Cork County Council Bantry Sewerage Scheme

Proposed Wastewater Treatment Plant at Bantry, Co. Cork

Addendum to the Environmental Impact Statement

Job Nr.: A6373

REVISED LAYOUT OF THE PROPOSED TREATMENT WORKS

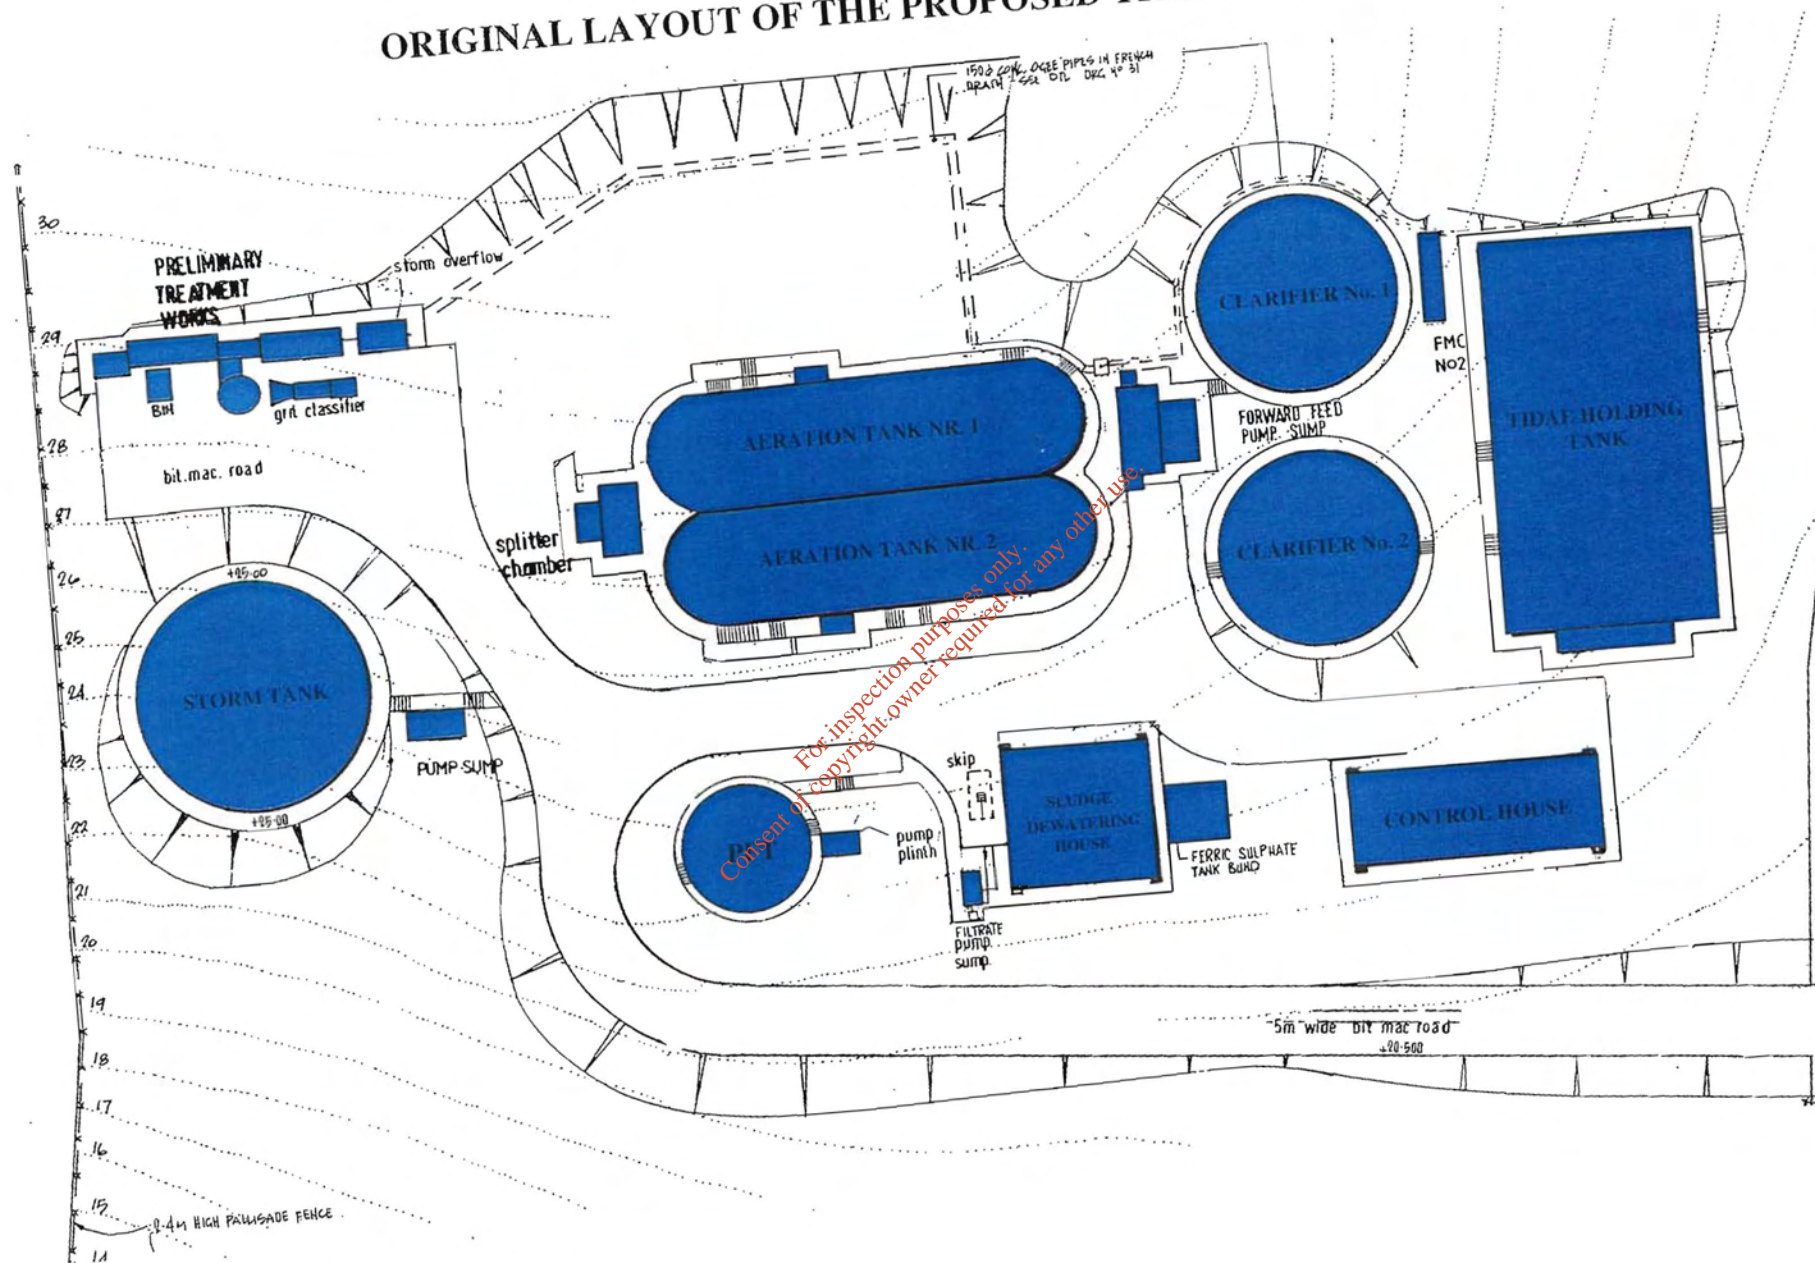
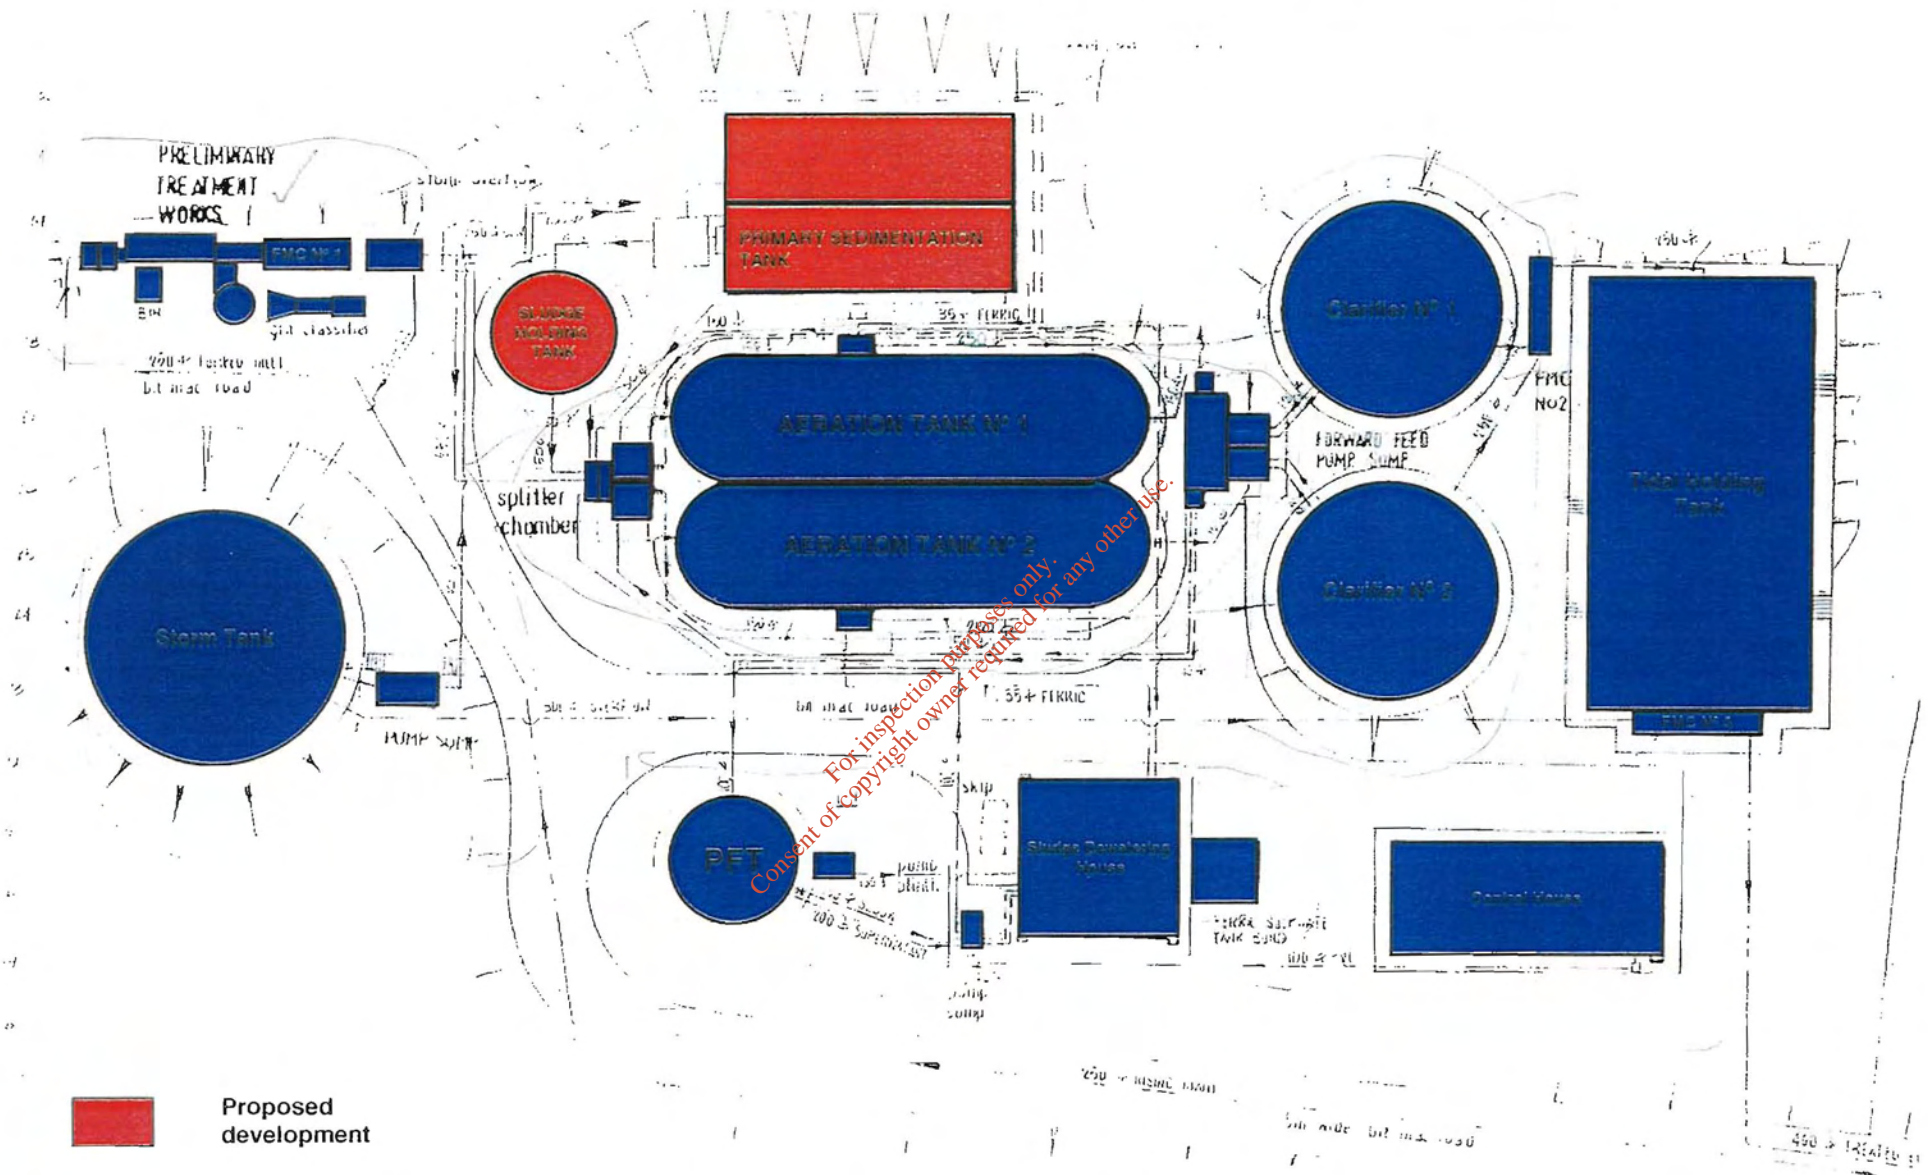
It is proposed to construct two primary sedimentation tanks and a sludge holding tank as addition to the wastewater treatment plant previously proposed in 1992.

The two rectangular primary sedimentation tanks will have dimensions 16 x 5.15 x 3.7 m each, and will be located to the north of the aeration tanks (see Appendix 2). The tanks will be equipped with sludge scrapers and sludge, which is collected in the tanks, will be pumped from the tanks to the proposed sludge holding tank.

The sludge holding tank will be a circular tank of 7.5 m diameter and capacity approx. 155 m³. This will be located between the preliminary treatment works and the aeration tanks. Sludge will be drawn off site by vacuum tankers. Supernatant liquor will be directed to the aeration tanks.
